EE SX Non Amplified Photomicrosensors (Transmissive) Change to Terminal Plating

PCN: PMS - 040
Ref No. 20260522_PDC_00003

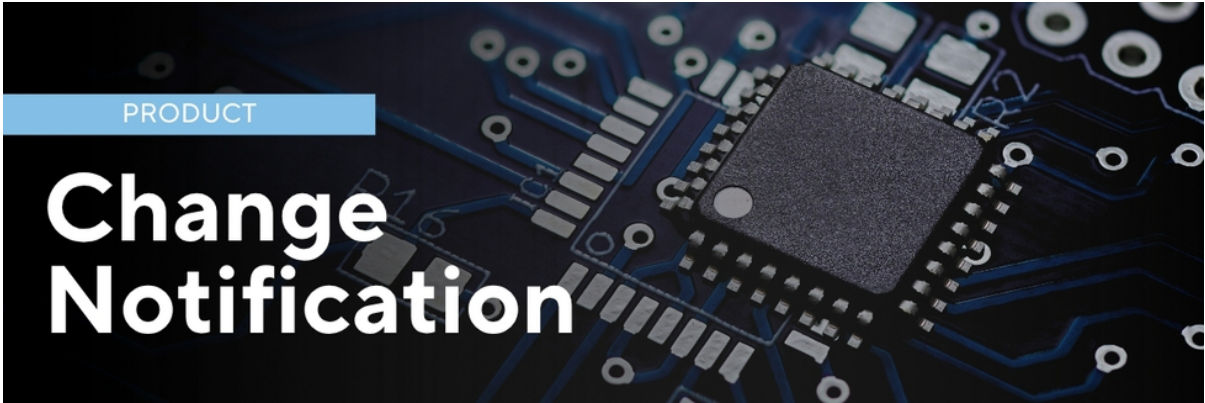
Effective as of our production beginning in October 2026, the terminals of five Non-Amplified, Transmissive Photomicrosensors will transition from Silver plating to Tin plating. This change will not alter the technical specifications or external dimensions of the affected Photomicrosensors. Should you have any additional questions, please communicate with your local Aratas Sales Representative.

Before the change	After the change
Terminal Surface: Ag plating (Silver plating) 	Terminal Surface: Sn plating (Tin plating)  * No changes in soldering temperature and dimensions.

Plating	
	(before change)	(after change)
EE-SX1018	Ag	Sn
EE-SX1025	Ag	Sn
EE-SX1035	Ag	Sn
EE-SX1046	Ag	Sn
EE-SX1055	Ag	Sn
